**From:** [REDACTED]  
**To:** [SizewellC](#)  
**Cc:** [REDACTED]  
**Subject:** Re Issue Specific Hearing 15 - Eastern IFCA comments on "The Sizewell C Project - Consultation Document - Consultation on Temporary Desalination Plant", dated August 2021  
**Date:** 06 October 2021 11:40:30  
**Attachments:** [2021\\_08\\_Desalination\\_plant\\_sizewell\\_c\\_project\\_consultation\\_document\\_updated\\_v2-compressed.pdf](#)  
[2021\\_08\\_23\\_Sizewell\\_C\\_Temporary\\_Desalination\\_Plant\\_Consultation EIFCA Comments.pdf](#)

**Sizewell C Project: Consultation on Temporary Desalination Plant**

# The Sizewell C Project

## Consultation Document Consultation on Temporary Desalination Plant

Figure 2.6: Typical outfall pipe with diffusers

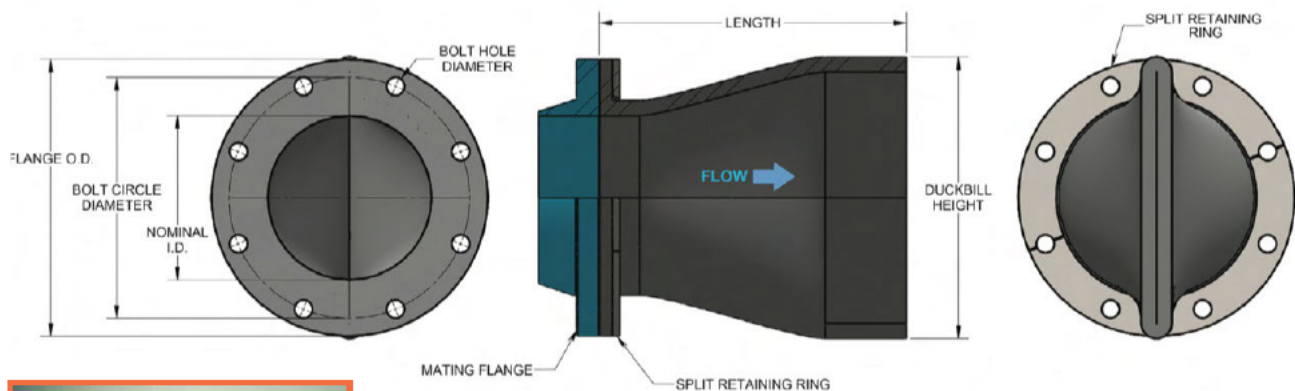
We consider it important that should the desalination project go ahead as described, that the intake pipe for that project and the discharge from the fish recovery and return system for Sizewell C (which will be in very close proximity to each other) are not in operation at the same time. This is acknowledged in Section 2.3.24 of the Consultation

We wish to offer a comment on the overall approach of the Temporary Desalination Project. As described in the Consultation Document, the project requires a bespoke water intake, treatment plant and brine return system. I’d like to ask please what if any consideration has been given to integrating this process with the overall site sea water management, specifically to incorporating the seawater intake and brine return systems with the existing Sizewell B cooling water flow? Would it be possible to take the seawater to feed the desalination plant from this water flow – ideally after it has passed through the reactor cooling system (in which case no additional seater extraction will be needed) or if that is not possible, from the seawater system before it is used by Sizewell B. Brine produced by the process could be returned to the cooling seawater flow prior to its discharge to the sea. My understanding is that the consented abstraction for Sizewell B is of the order of 5 000 000 m<sup>3</sup> / day, and that the proposed sea water to abstracted for desalination (10 000 m<sup>3</sup> / day) or returned as brine (6 000 m<sup>3</sup> / day) represent only some 0.2 / 0.12 % respectively of this.

- The proportion of change in the amount of seawater that would be extracted is minimal, and I would imagine could well be within existing consents.
- There will be no need for new “at sea” works (intake pipe, discharge pipe) with associated potential environmental impacts, and costs.
- The brine returned to the sea would be diluted by a large factor of up to 800 (depending on the actual flow of cooling water to the Sizewell B facility at any time), and thus render any effects to all intents and purposes undetectable.
